<b>Subject:</b>  FUEL TANK IS DIFFICULT TO FILL	<b>Bulletin No:</b> 01-013/15
	<b>Last Issued:</b> 07/14/2015

2010-13 Mazda3 (including Mazdaspeed3)

2012-15 Mazda5 vehicles with VINs lower than JM1CW\*\*\*\*\*176622 (produced before June 2, 2014)

Mazda5

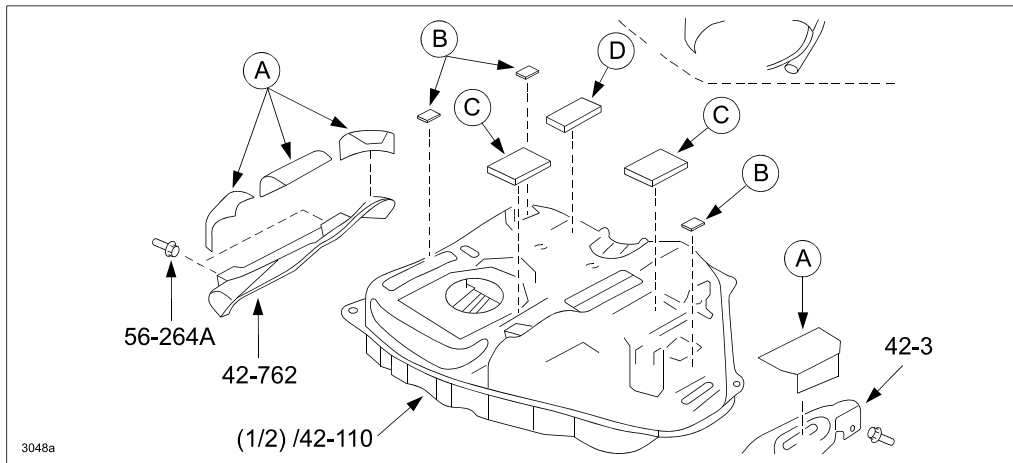
Part Number	Description	Qty.	Notes
CG36-42-110C	Fuel Tank	1	Replace part
GN3A-42-166	Gasket, Fuel Pump	1	
LF07-40-305A	Gasket, Main Silencer Front	1	
Z501-40-581A	Seal Ring, Main Silencer Rear	1	
GJ6A-42-763	Pad ("A" in Figure)	4	
C235-42-761	Pad ("B" in Figure)	3	
BP4K-42-761	Pad ("C" in Figure)	2	
FD01-42-761	Pad ("D" in Figure)	1

Mazda3

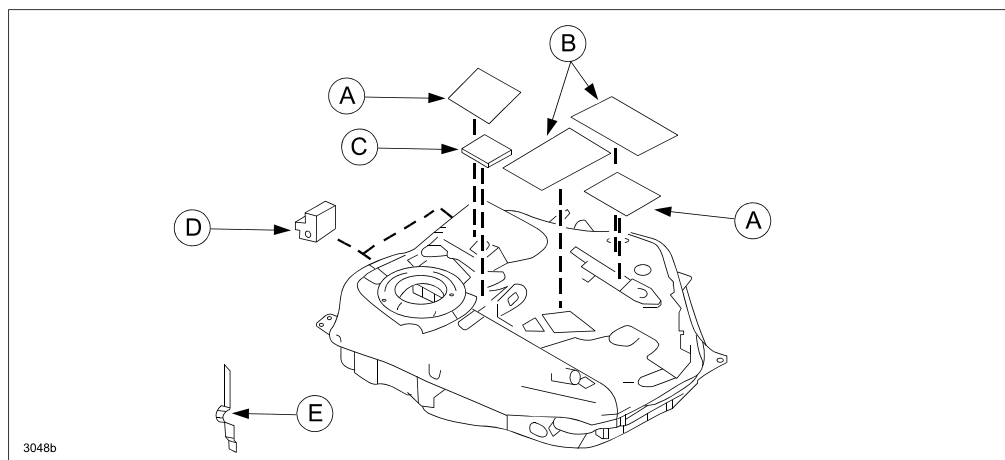
Part Number	Description	Qty.	Applicable Engine				Notes
			SKY- ACTIV 2.0L	MZR 2.0L	MZR 2.3T	MZR 2.5L	
BFD1-42-110F	Fuel Tank	1	X				
BBM2-42-110G	Fuel Tank	1		X			
BBM7-42-110H	Fuel Tank	1			X	X	
BBM2-42-166A	Gasket, Fuel Pump	1	X	X	X	X	Replace part
L315-40-581	Seal Ring, TWC Front Side	4			X		
LF07-40-305A	Gasket, TWC Front Side	3	X	X		X	
PE23-40-305	Gasket, TWC Rear Side	2	X	X	X	X	
9994-61-000	Nut, TWC Rear Side	1	X	X	X	X	
BP4K-42-761	Pad ("A" in Figure)	1	X	X	X	X	
LC62-42-761A	Pad ("B" in Figure)	1	X	X	X	X	
B455-42-761	Pad ("C" in Figure)	1	X	X	X	X	
BFD1-42-763	Pad ("D" in Figure)	1	X				
BBM2-42-763B	Pad ("D" in Figure)	1		X	X	X	
BBM2-42-755A	Tape ("E" in Figure)	1	X	X	X	X
